Replacement Dwelling at 115 Frognal Ref: 2016/5380/P

This letter now provides comment on the amended plans.

Ground floor - red outline shows new footprint. Dotted blue line shows areas removed

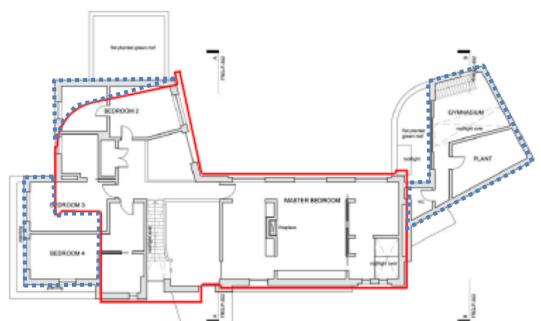
The reductions that have been proposed in terms of the mass at first floor level do represent an improvement when compared to the original proposal which effectively filled the whole site from Oakhill Way round to 113 Frognal.

However, two substantial areas of additional concern remain. These are firstly at ground floor level in terms of the extent of the garage to the west side which still completely fills the whole of the gap to the boundary and secondly the depth of the rear first floor projection toward No.113.

The proposed garage appears to scale at over seven metres in width, and could readily be reduced to retain a visual gap between it and the neighbouring garage block.

Proposed additional massing compared to existing

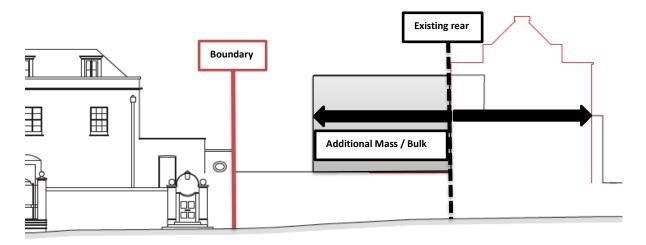
Most importantly however is the rear two storey projection. As shown below, this has not been materially altered (in terms of mass / bulk / height) from the originally submitted proposal.

As shown above the rear two storey projection is approximately the same width / depth as the existing house, effectively doubling the mass visible from the lane. This element significantly closes the open aspect between the side of No. 113 and the rear of No.115 and would be extremely prominent and dominant in views. It also has a significant impact upon the amenity of No.113 as discussed below.

Proposed relationship with development directly adjoining the boundary (3D model not updated in latest submission but first floor relationship remains constant)

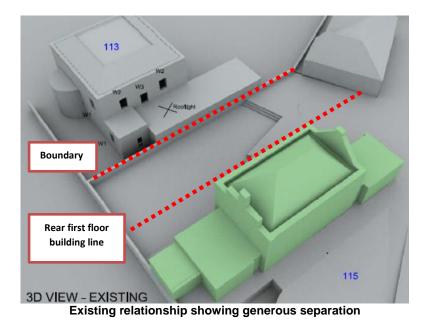
As is apparent from the existing drawings (and site view), the rear of No. 115 currently stands some 12 metres from the boundary with our client's property No. 113. This provides a sense of space and is part of the amenity enjoyed by No. 113 i.e. our clients do not currently feel dominated and oppressed by neighbouring built form. The relationship is perhaps best emphasised by reference to the 3D modelling which has been included within the submitted daylight, sunlight and overshadowing report.

The first-floor element as proposed would be just 4.5 metres from the boundary and just 9.5 metres from the side elevation of No.113 as shown above and so would introduce significant bulk within close proximity of the first floor bedroom window of our clients property.

The relationship would be overbearing and unneighbourly and we submit should be recessed further back from the boundary where it rises above ground level.

East elevation as proposed with new mass / bulk of rear projection shown

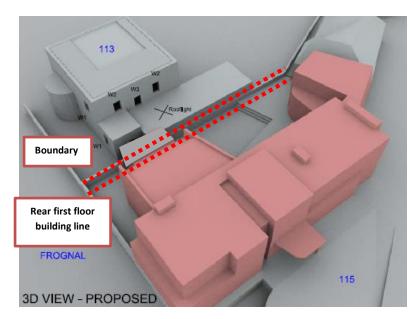
The relationship between No.113 and No.115 is side gable to main rear elevation. There is 5 metres between the main first floor element of the side wall of No.113 and the boundary. This is a reasonable relationship. However this does not mean that the 4.5 metres that the applicant proposes from the main rear elevation of the proposed house to its rear (not side) boundary is comparable or appropriate. It is always the case that houses are set much closer to their side than rear boundaries.
